Project: Consent Application LU/0077/23 - RS Sand Limited **Memo:** 1/R0 **Page:** 1 of 8

Topic: Response to a Request for Further Information – Landscape and Visual Effects

Date: 20 September 2023

Figure 1: ZTV Existing Site from 37 Lovells Road

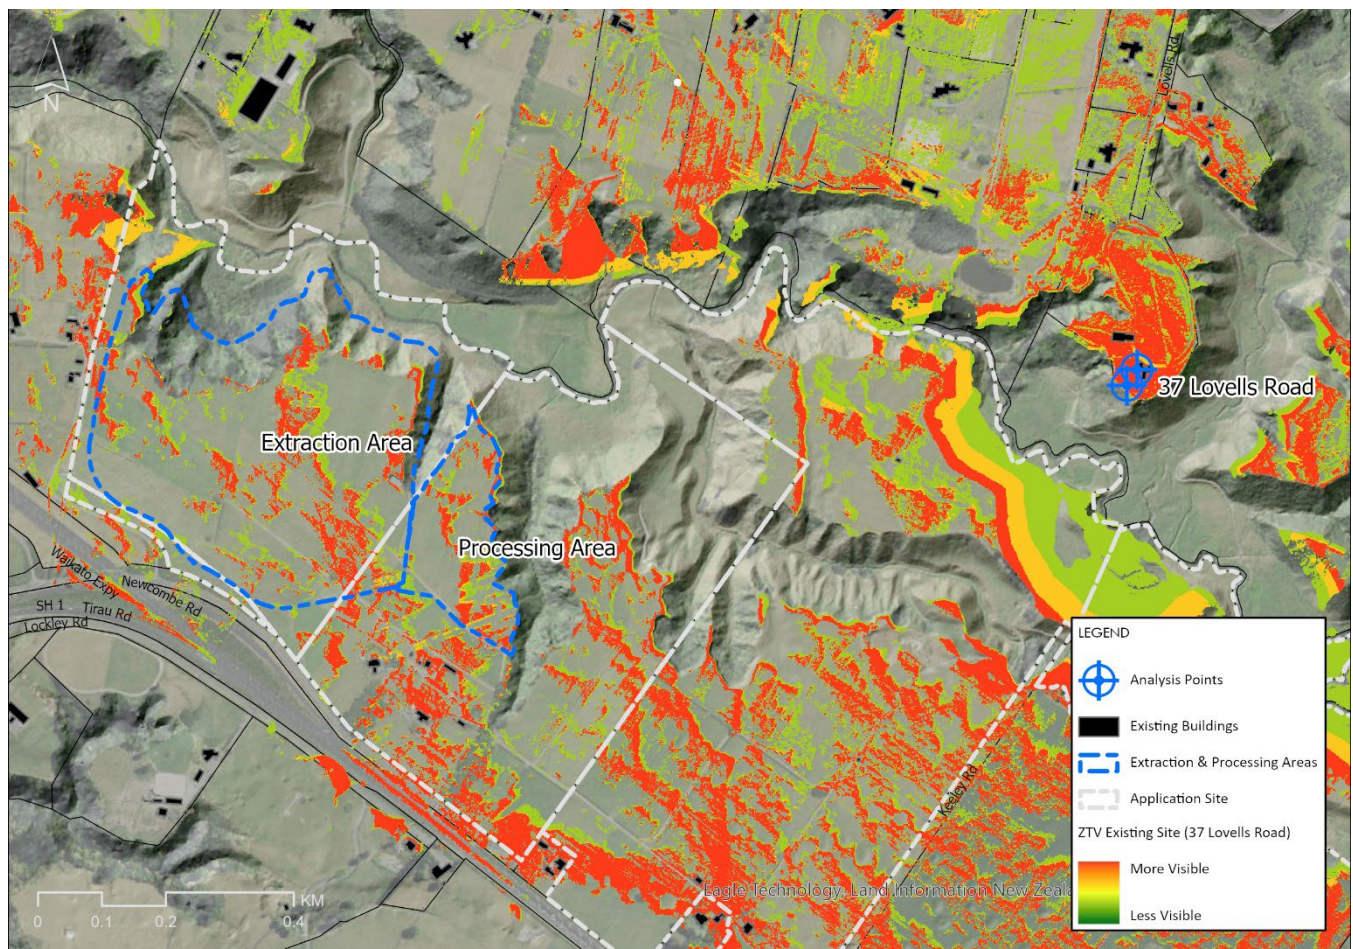
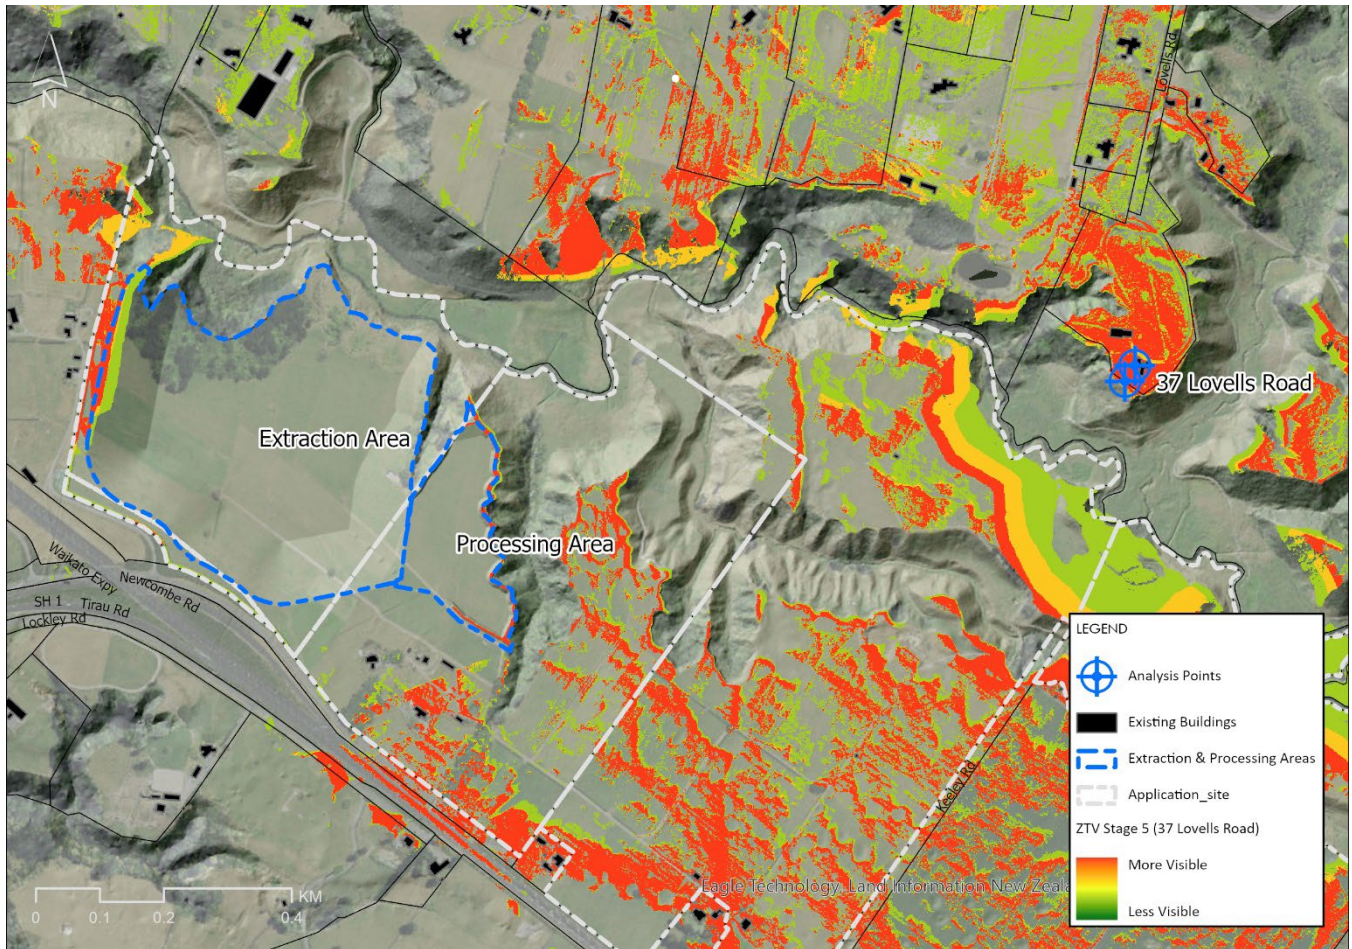
Provide an assessment of visual effects for the property at 37 Lovells Road.

The following ZTV analysis maps (Figures 1 and 2) show the difference in the visibility of the site between the existing landscape and the completed quarry. The analysis takes into consideration views from ground level and within the first story of the house.

The effects of the proposal from this location, where only limited views of the site are available, (bund formation and potentially the top of stockpiles and processing plant), will likely range between **very low - low** (*less than minor*) during the operational stages of the quarry. **Low** levels of adverse effects are likely to occur during the early stages of the quarry's development; Stage 1 when the bunds are being formed, and during Stage 5 rehabilitation of the quarry when the bunds are potentially removed and used to assist with minor reshaping internal to the remnant batters. **Very low** effects will occur for the balance of the quarrying until rehabilitation of the site occurs. Following the completion of rehabilitation, the restored landform will have a negligible (below *very low*) adverse effect on the landscape and visual amenity values from this view location.

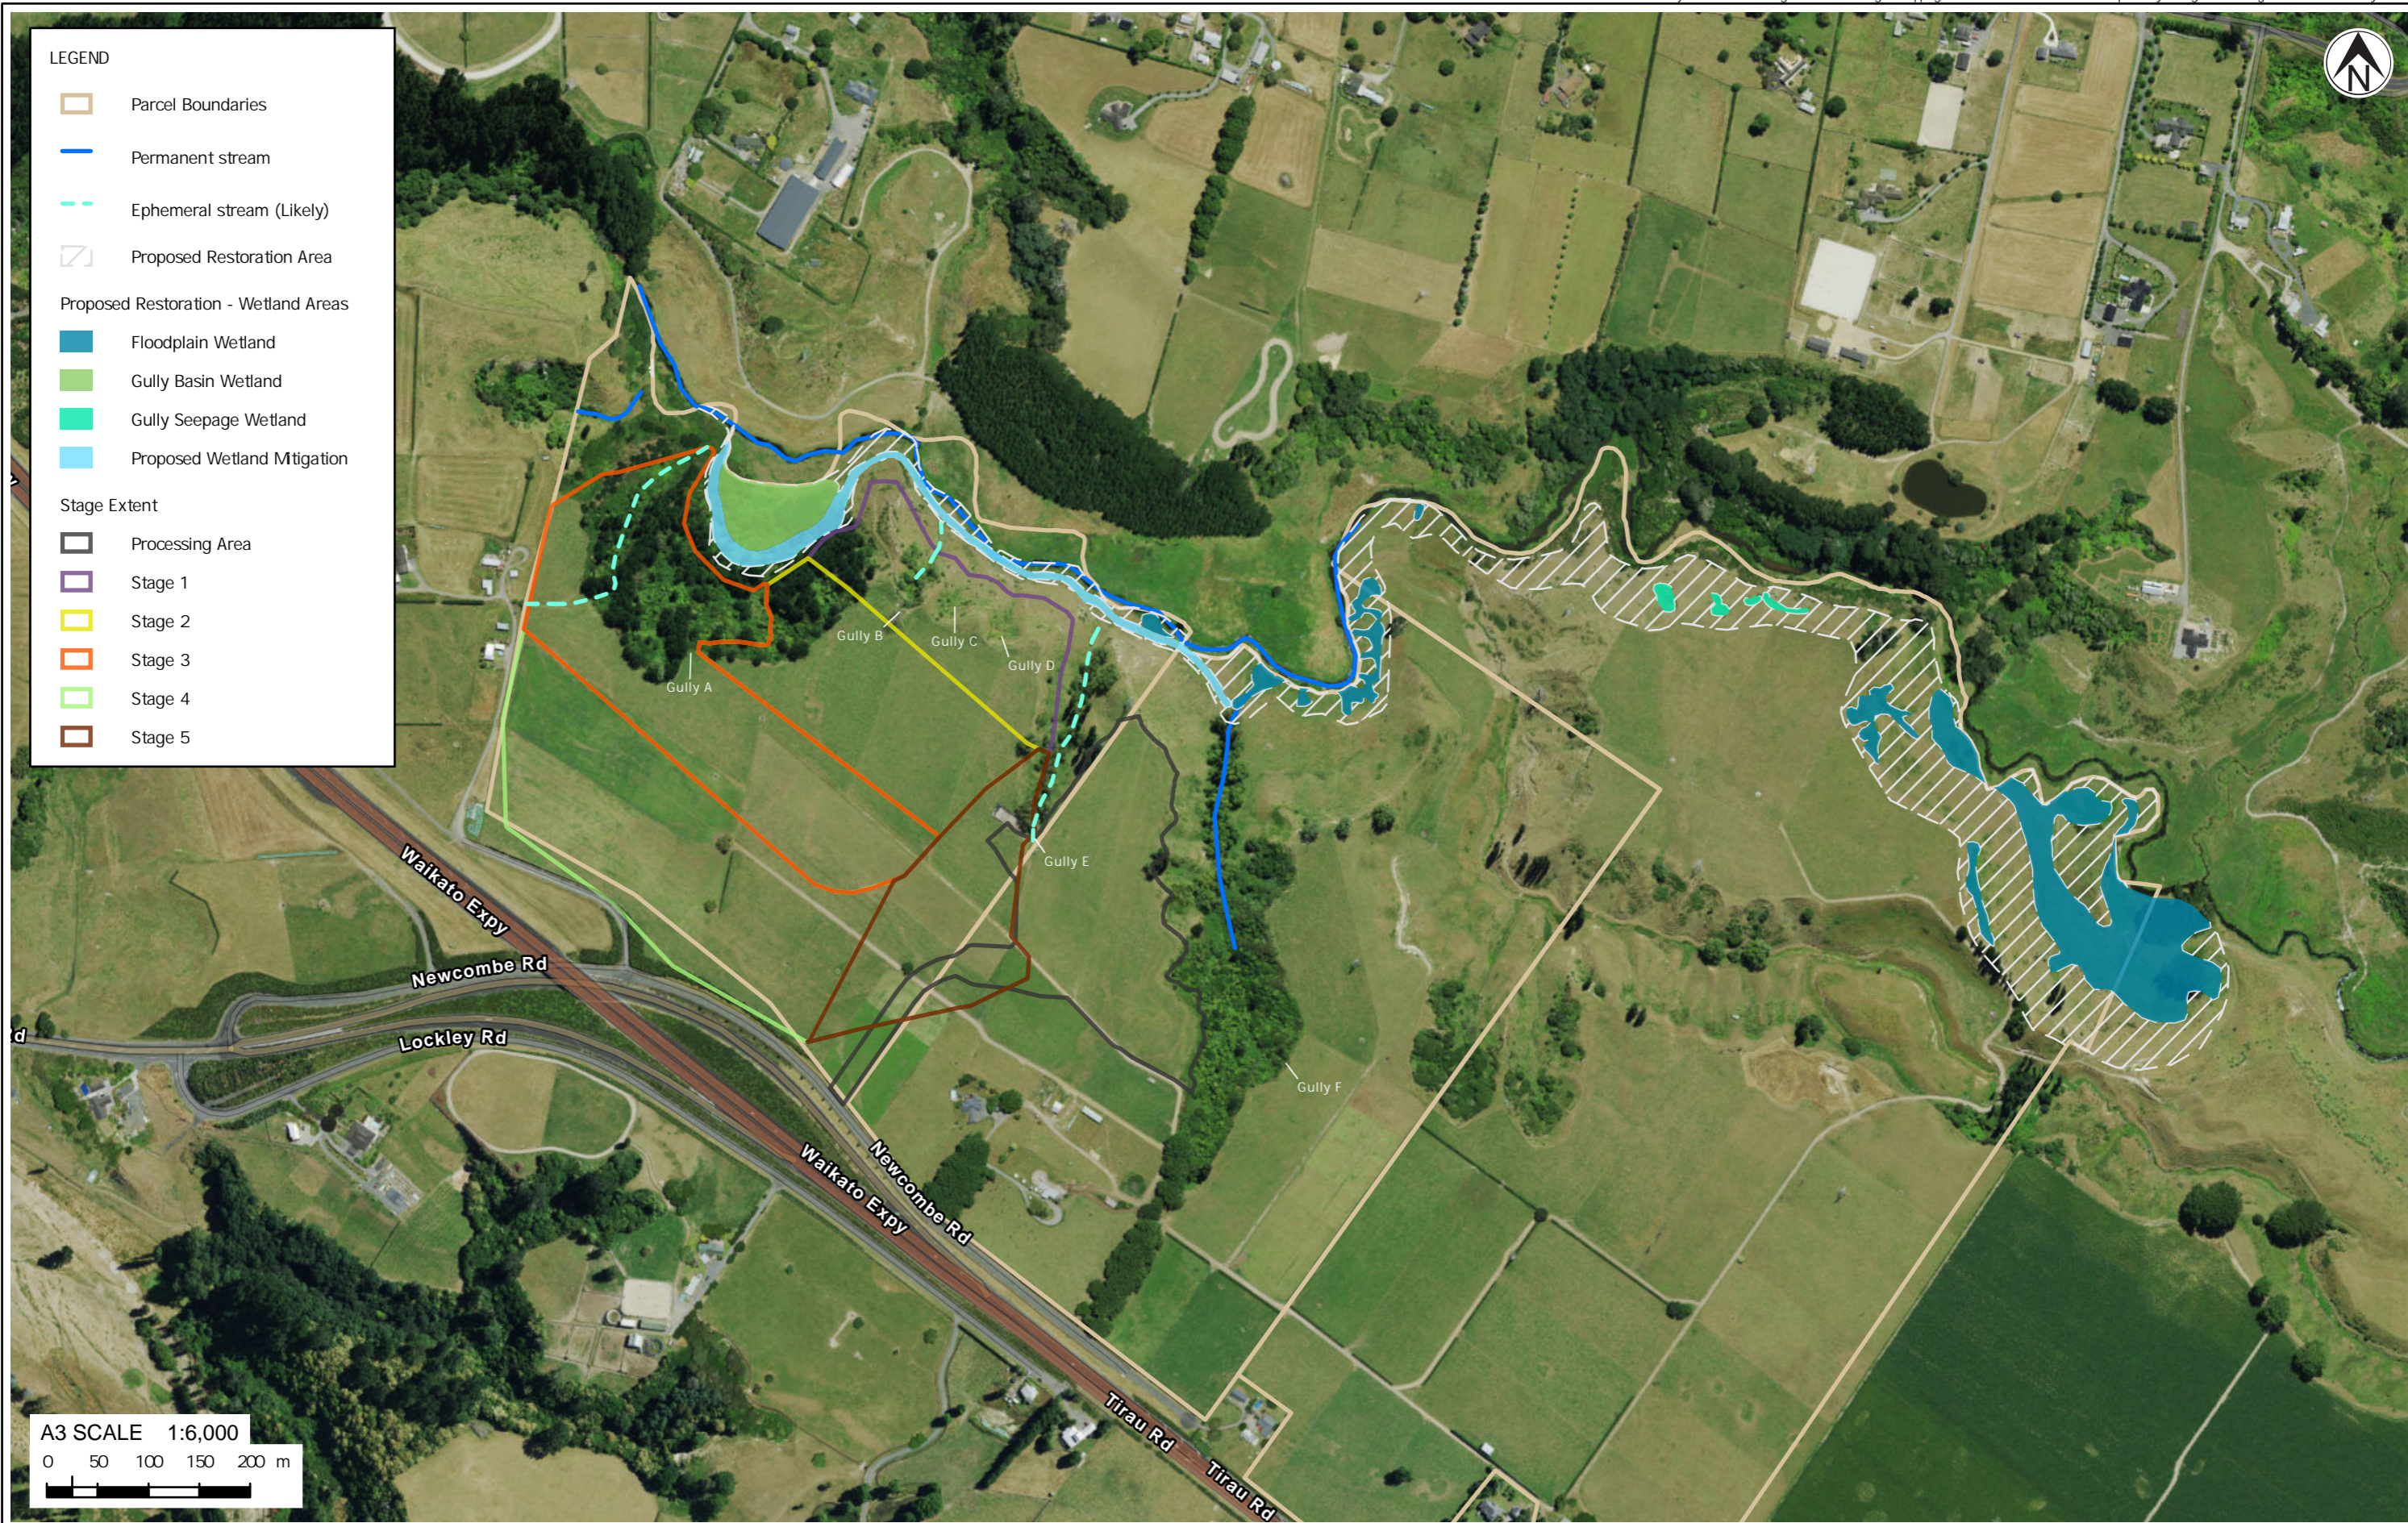
Further analysis should be provided in the assessment on the landscape and visual effects related to the removal of the large area of tree and shrub vegetation to enable extraction. will be sufficiently mitigated, from a landscape and visual effects perspective.

This area of planting is located on the northwestern portion of the site and is comprised of pine with an understorey of exotic weed species. It is located within a section of the gully wall that has eroded out in a broader and shallower manner than the other more incised tributary gullies systems that adjoin the Karapiro Stream. This area is across approximately 40% of the northern boundary of the quarry excavation area (excluding the processing area). Within the landscape context, the planting appears to have been established as part of the stabilisation of the gully wall and is similar to other stands of exotic vegetation planting in other parts of the gully. The colonisation by weed species gives evidence to the challenge of accessing this area.

As part of the quarry excavation, approximately 50% of this planted area will be removed. The lower portion of the gully wall will be retained and, in conjunction with the flood plain area, be rehabilitated with indigenous species as part of the proposed mitigation strategy.

Overall, it is considered that, within the context of the development, the removal of the pine trees on the upper slopes of the gully wall will have a **very low** adverse effect on landscape and amenity effects. The stand of pines is a pragmatic planting, and the screening effect is incidental. While the upper area of the pine tree provides some low-level screening of the pasture to the south, when viewed from adjacent properties to the north, its removal does not expose any unexpected or incongruous elements within the view but rather allows more distant views of typical components of the rural landscape setting. The proposed mitigation and rehabilitation planting contained in the mitigation strategy is considered an appropriate response to the reduction in the extent of the stand and the species it contains.
